**Committee of Experts on the Transport of Dangerous Goods
and on the Globally Harmonized System of Classification
and Labelling of Chemicals****Sub-Committee of Experts on the Transport
of Dangerous Goods****Fifty-fourth session**

**Classification criteria and related hazard communication:
Work of the Sub-Committee of Experts on the Transport
of Dangerous Goods (TDG) on matters of interest to the
GHS Sub-Committee****Use of the Manual of Tests and Criteria in the context of
GHS****Transmitted by the Chairman of the Working Group on Explosives of
the Sub-Committee of Experts on the Transport of Dangerous Goods
(TDG Sub-Committee) on behalf of the Working Group***

1. This document contains the proposed list of amendments to Part II, Sections 20 to 28 of the sixth revised edition of the Manual of Tests and Criteria, including Amendment 1, to take account of its use in the context of the GHS, for consideration by both sub-committees.
2. For practical reasons, the text of Part II of the Manual of Tests and Criteria with the proposed changes in visible mode is circulated separately, in English only, in informal document INF.3.

Figure 20.1(a): Renumber to 20.1 and replace the figure and its heading with the following

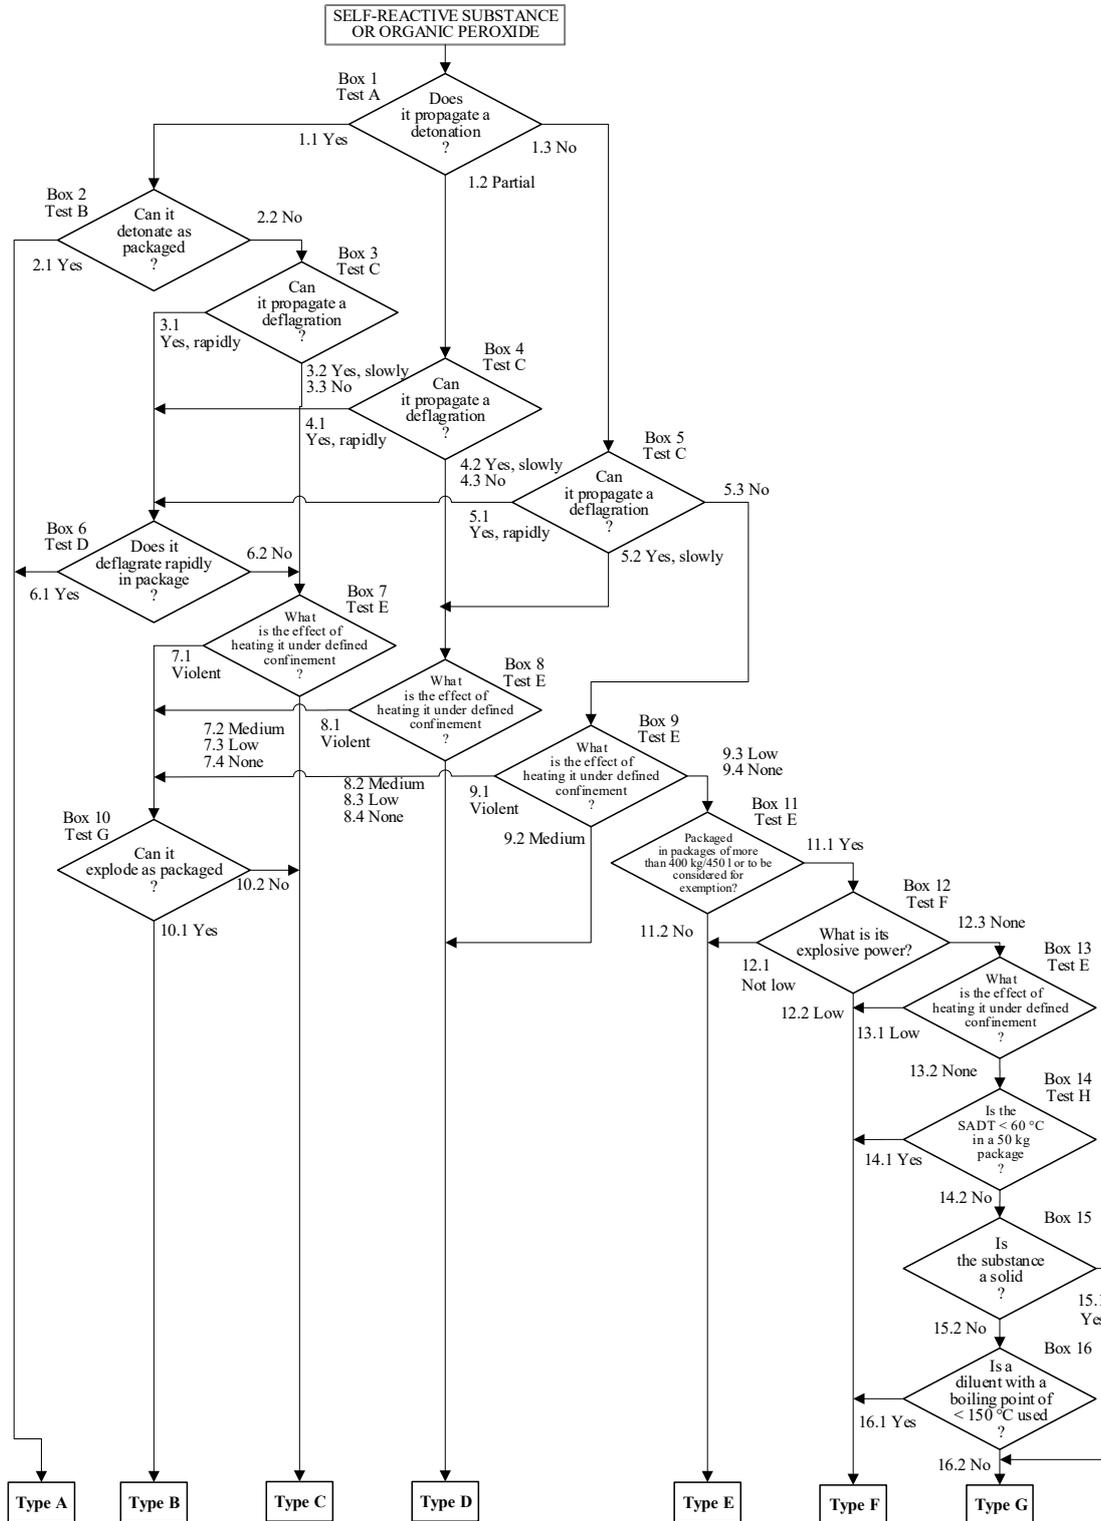
Delete Figure 20.1(b)

Add the following note to new figure 20.1

Note: For transport:

- Type A: not accepted for transport in that packaging;
- Type B: accepted for transport in packages of not more than 25 kg net mass with an “Explosive” subsidiary hazard label;
- Type C: accepted for transport in packages of not more than 50 kg net mass;
- Type D: accepted for transport in packages of not more than 50 kg net mass;
- Type E: accepted for transport in packages of not more than 400 kg/450 litres;
- Type F: may be considered for transport in IBCs or tanks;
- Type G: shall be considered for exemption.
